Service Bulletin

Bulletin No.: PIP5248A

Subject: Shudder And/or Hard shifting Into 1st Gear Or Reverse Vibration On launch (With Excessive Crankshaft End Play)

Models: 2014-2015 Chevrolet Corvette
Built with an 6.2L, LT1, LT4 engine and auto or manual transmission

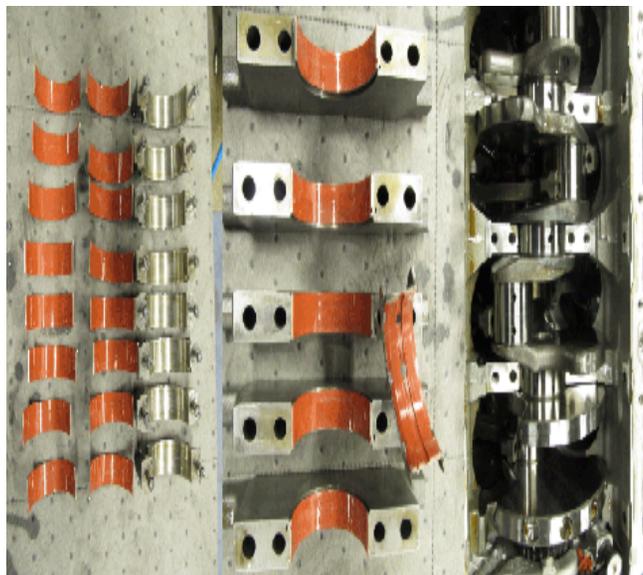
Check to determine if the crank shaft end play is within specification 0.0015–0.0086 in (0.040–0.220 mm).

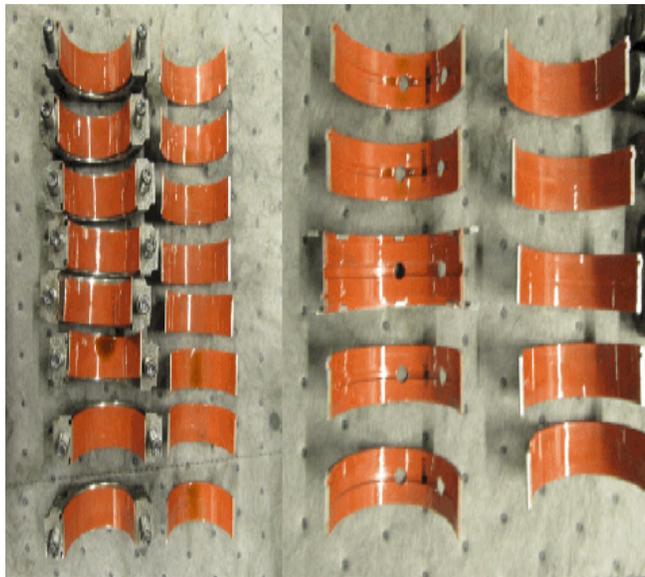
If end play is found to be out of specification, remove engine and inspect for possible Crankshaft thrust bearing and/or crankshaft for wear.
